OAKLANDS FARM SOLAR PARK

Non-Material Change Supporting Statement (EIA Addendum)

Document Ref: EN010122/NMC/1.1

ENVIRONMENTAL STATEMENT – NON-MATERIAL CHANGE SUPPORTING STATEMENT (EIA ADDENDUM)

FIGURE 1:
Revised Parameter Area for Work no.1 and indicative PV panel layout

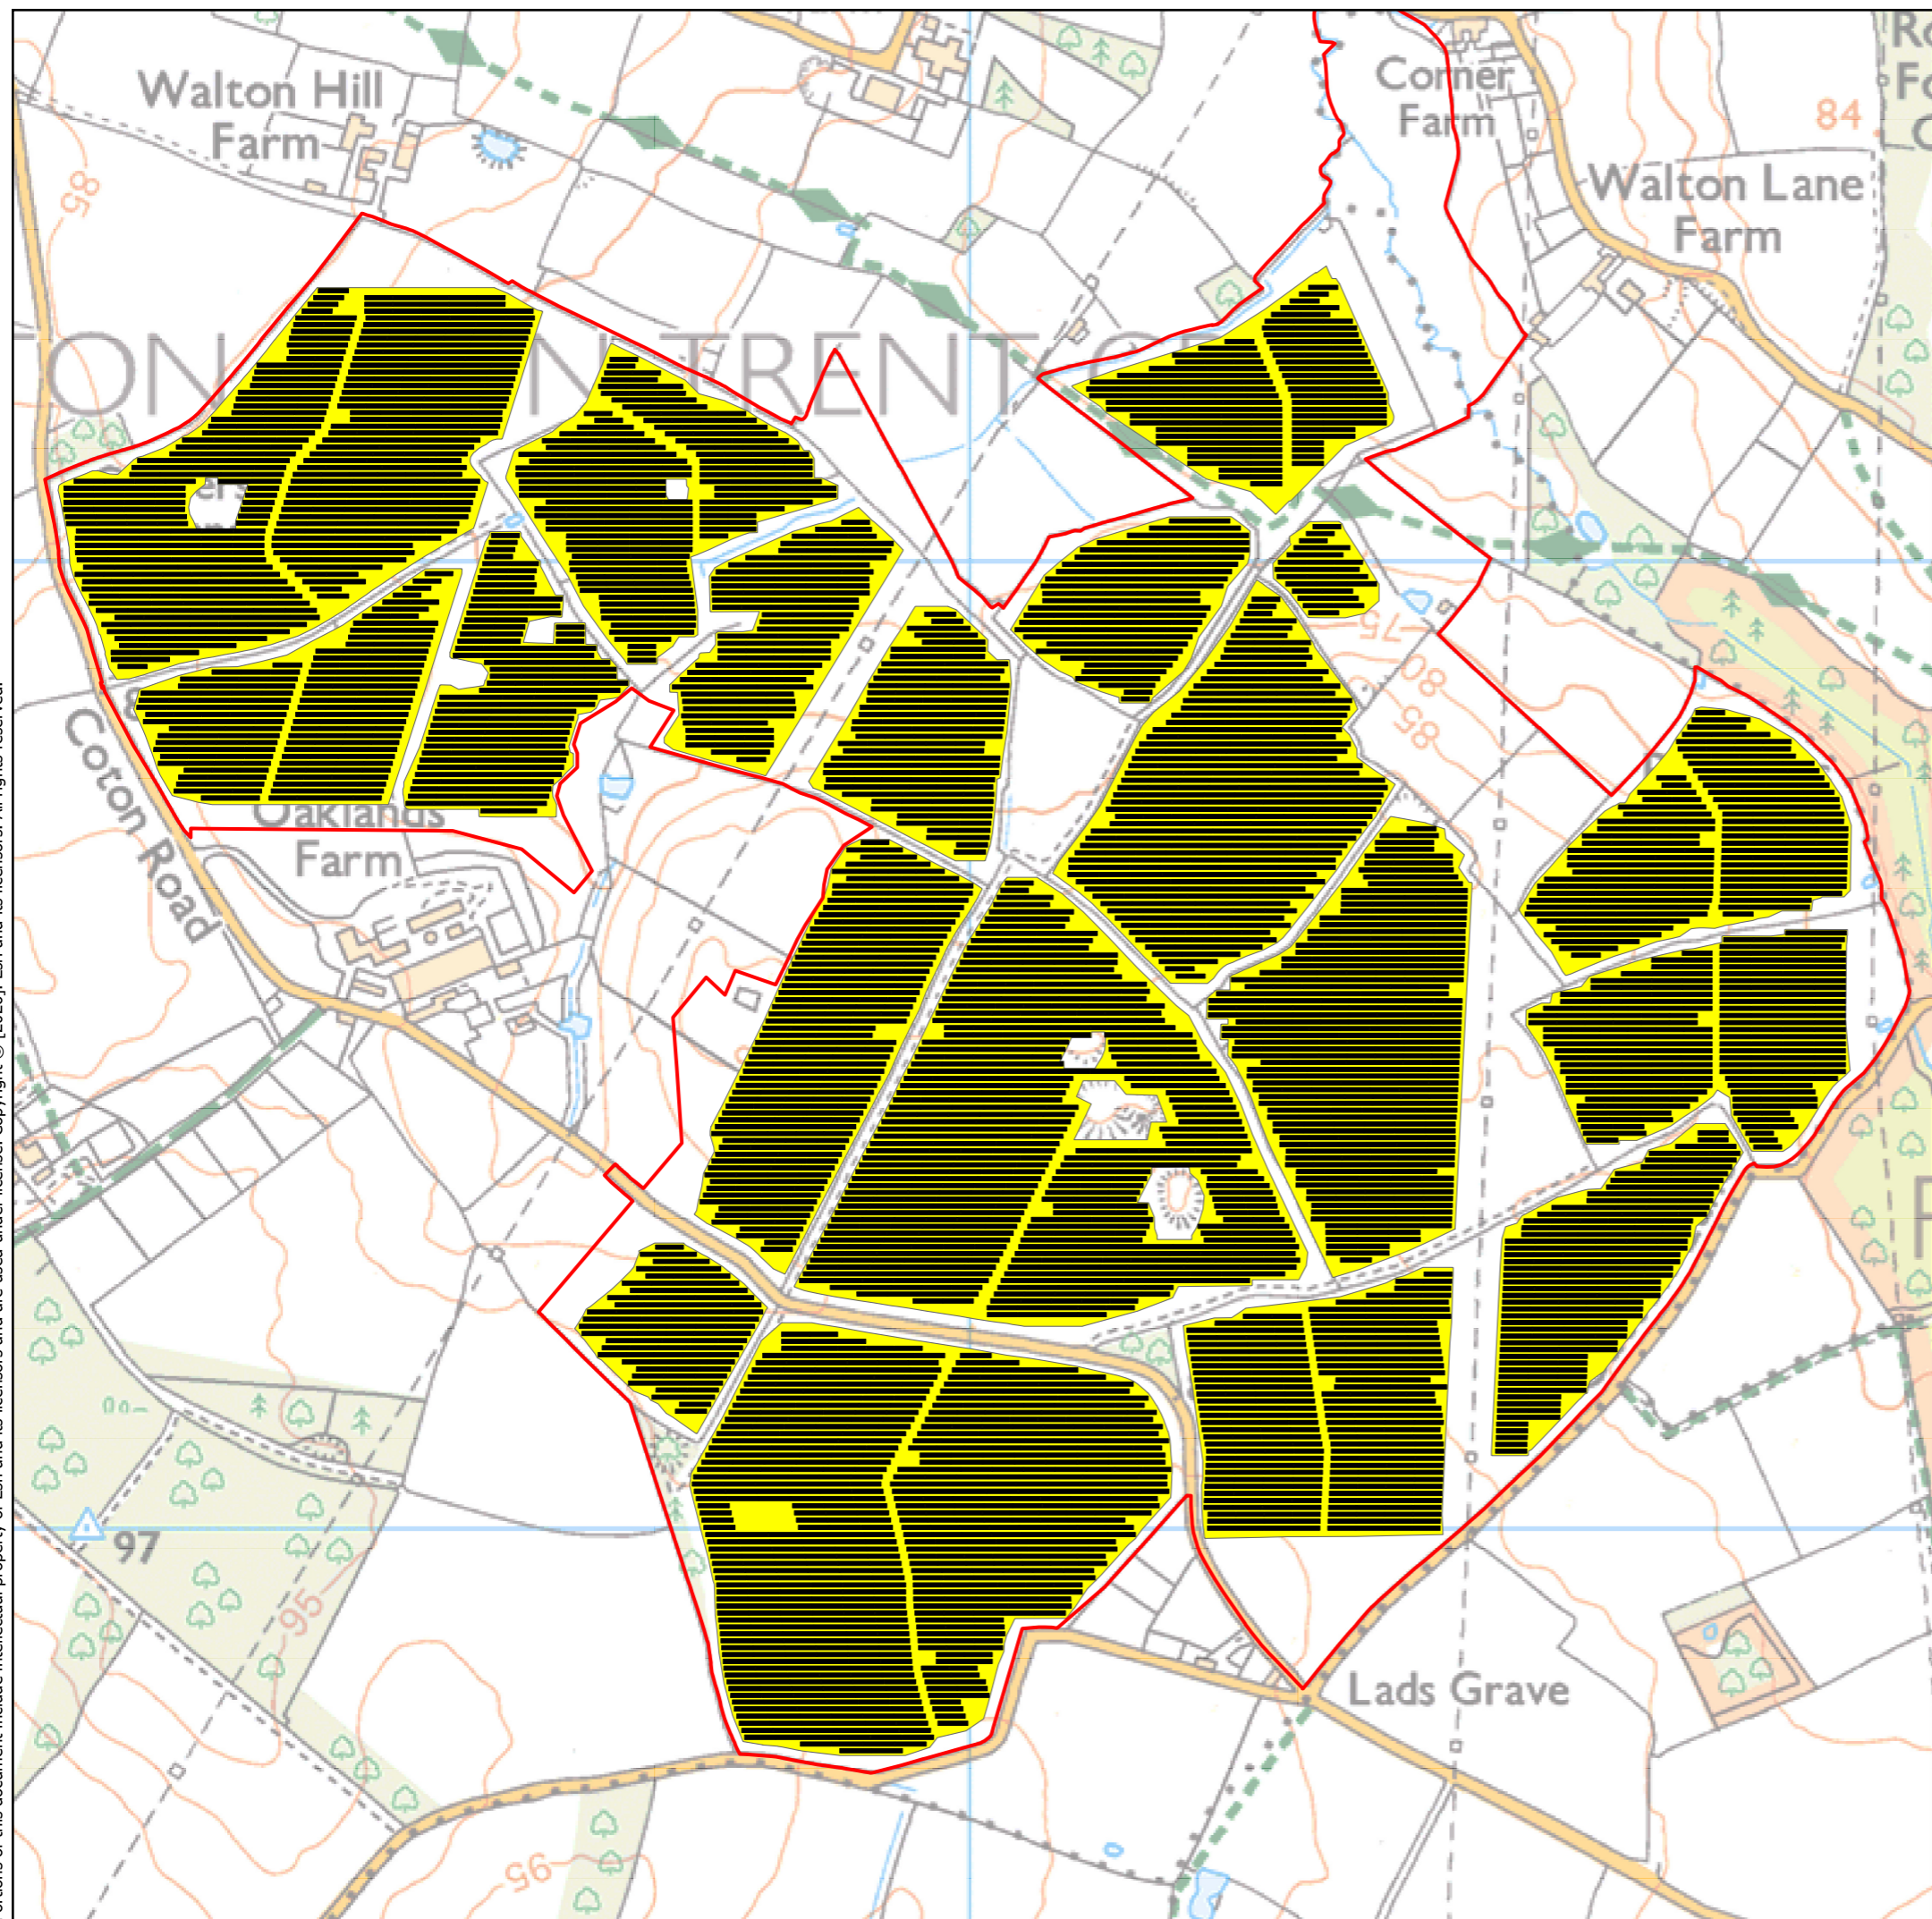
- 3.2.1 Through detailed procurement and design processes, the Applicant has been able to optimise the design by using newer technology. This primarily means the available land can be more effectively utilised to lay out the equipment to maximise efficiency and solar capacity. For example, more powerful inverter units can individually support a greater number of solar panel tables, and therefore more configurations of panel rows are possible to fit into irregularly shaped fields. Similarly, higher output solar panels mean the solar panel tables can be longer and therefore deployed more effectively in awkwardly shaped areas. To realise these optimisations, the Applicant proposes to slightly expand the footprint of work no. 1 in specific areas as shown in Appendix A and the revised Work Plans (Ref: EN010122/NMC/2.3). In addition, through the detailed design process the Applicant has identified three small areas which can be removed from the work no. 1 parameter area comprising the entirety of field 010, part of field 020 and a small area in field 04. This is because it is impractical to install solar panels in these areas due to the topography. The new amended area for work no. 1 along with an indicative solar panel layout is provided at Appendix A.

- 3.2.3 The revised Works Plan (ref. EN010122/NMC/2.3) captures the amendments to the parameter area of work no. 1.

FIGURE 2:
Work no.1 Area Comparison Plan

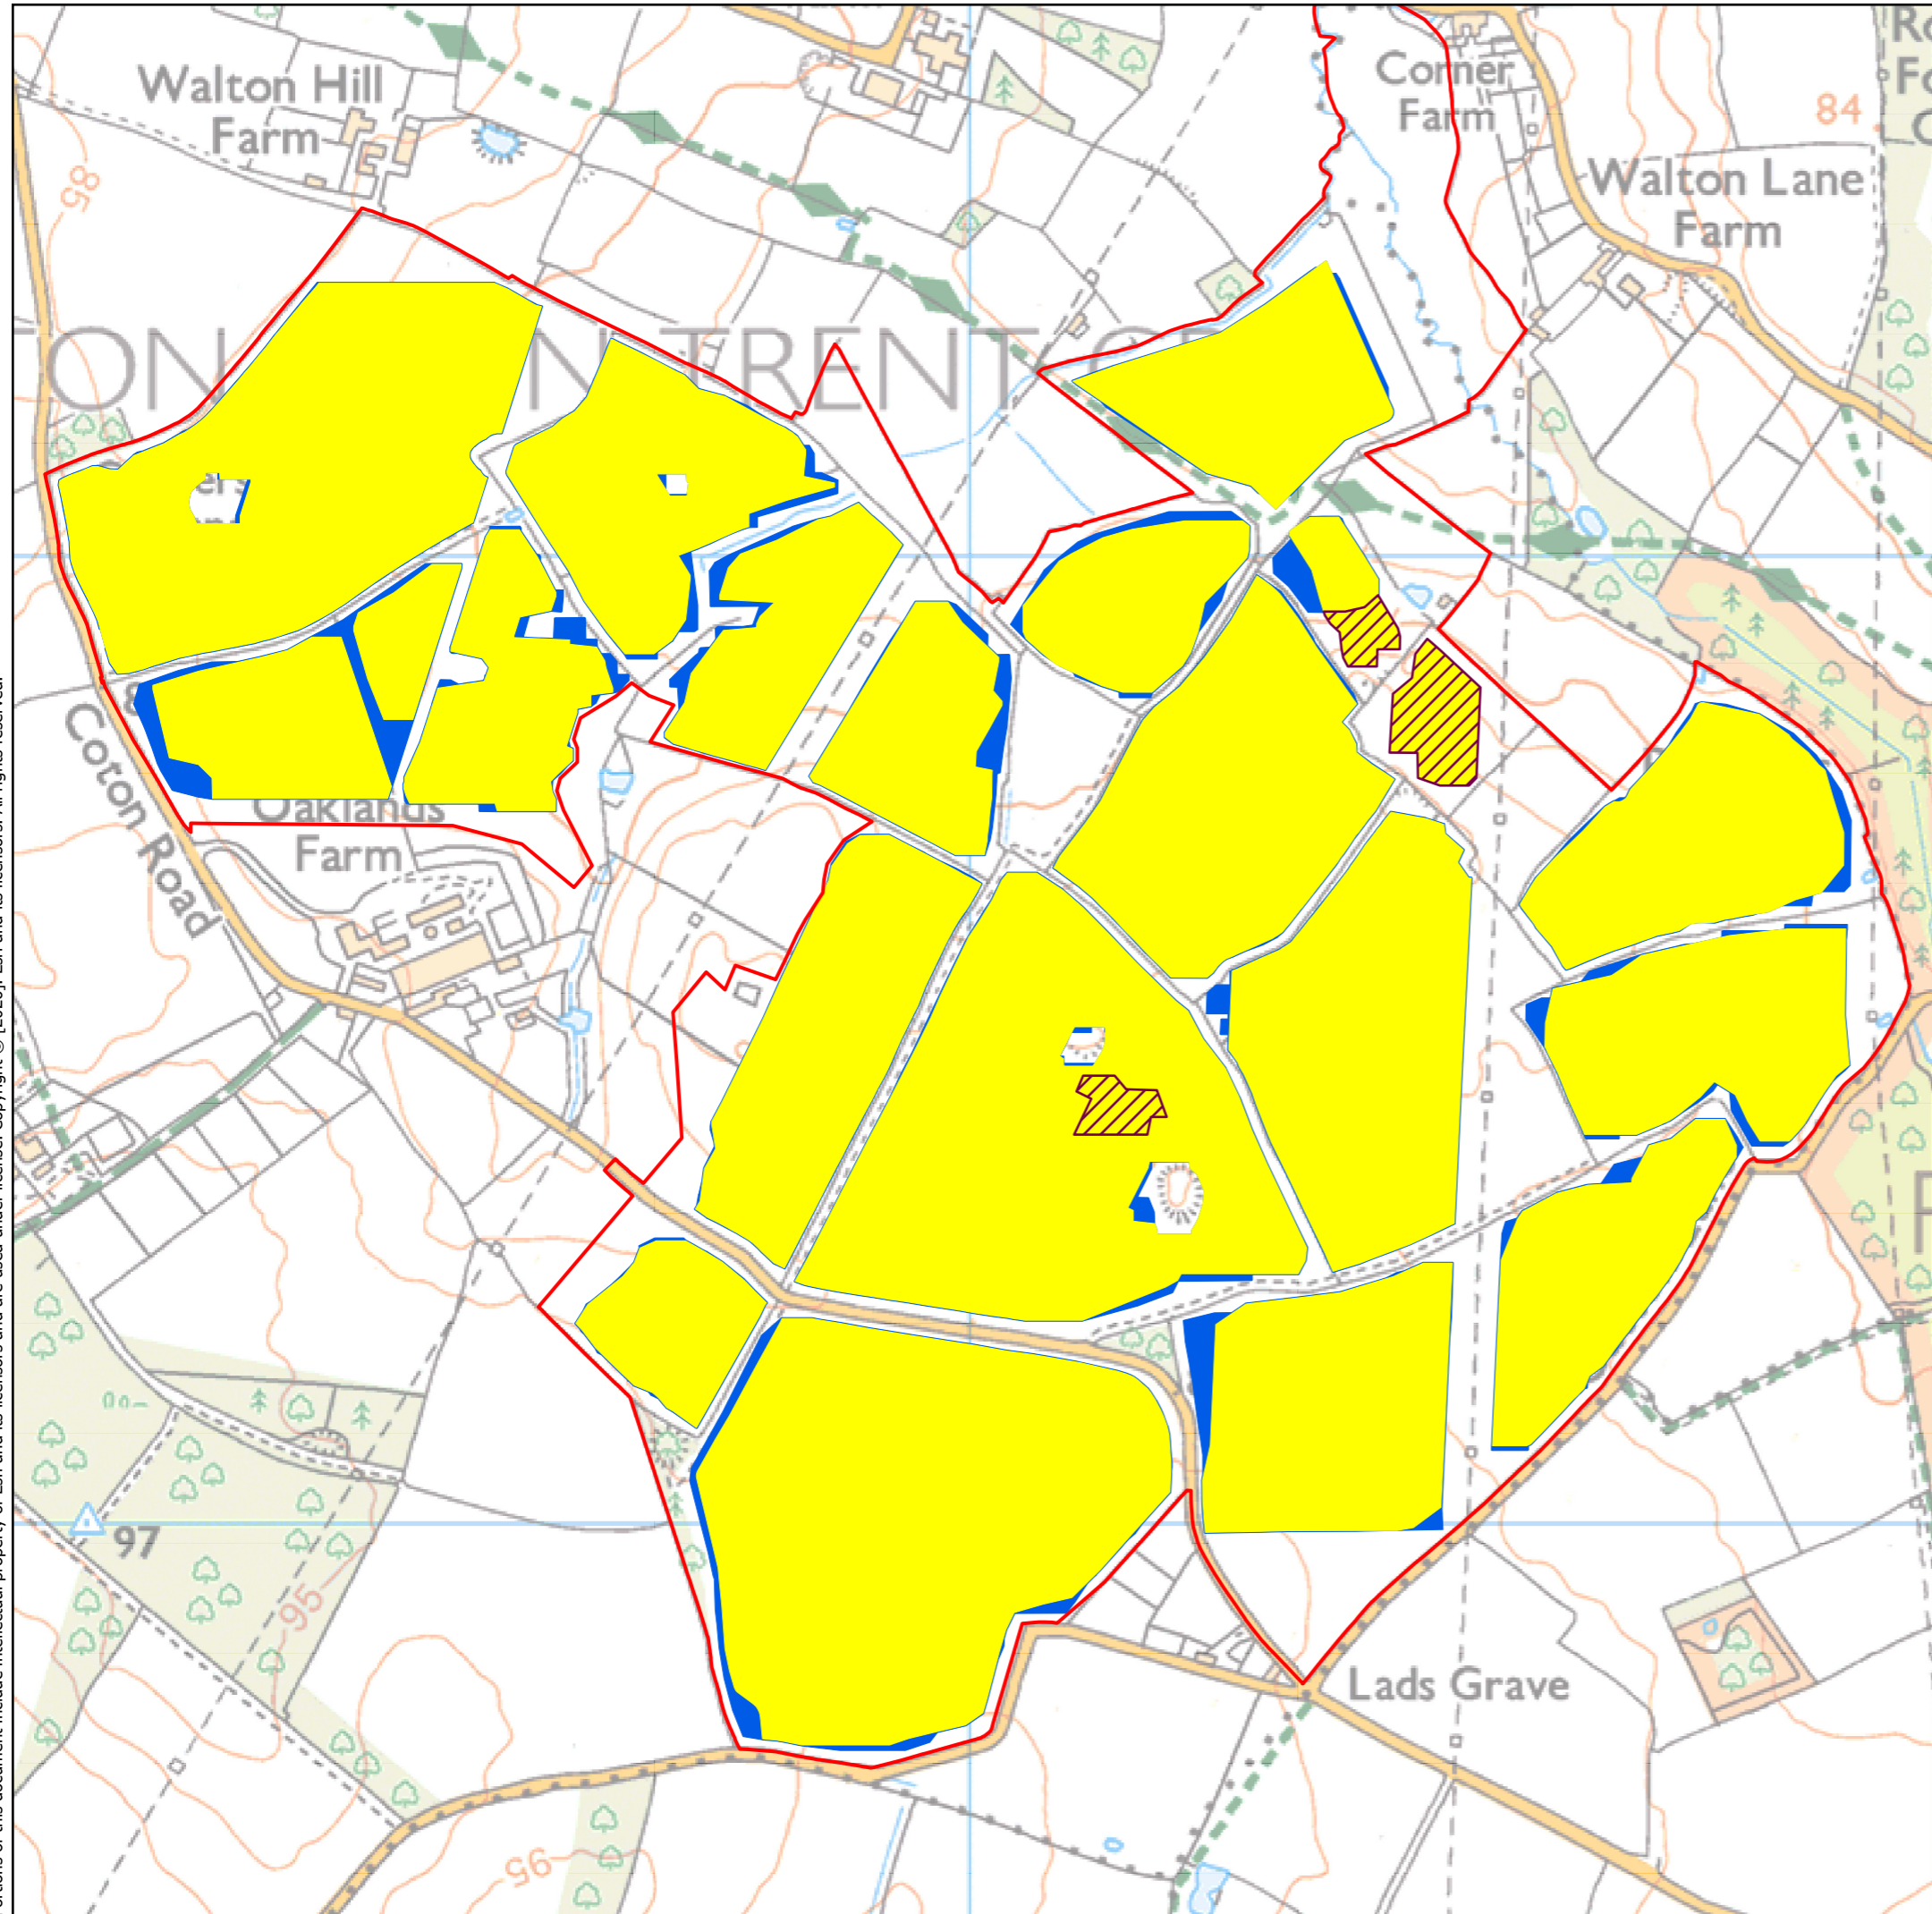
- 3.2.2 A Comparison Plan between the existing work no. 1 area and the proposed work no. 1 area is attached at Appendix B which highlights where the areas of work no. 1 have been extended and removed. This clearly shows that the proposed expansion accords with the general footprint of the Proposed Development. The Applicant considers the extensions are minimal, resulting in an overall increase of only 3.4% in the parameter area of work no. 1. Therefore, this change is non-material.

no. 1 and installation of solar panels particularly field 010 is now omitted and part of field 020 is reduced. There is likely to be a nominal benefit in terms of landscape and visual amenity however, this benefit is de minimis and does not significantly change the landscape strategy.
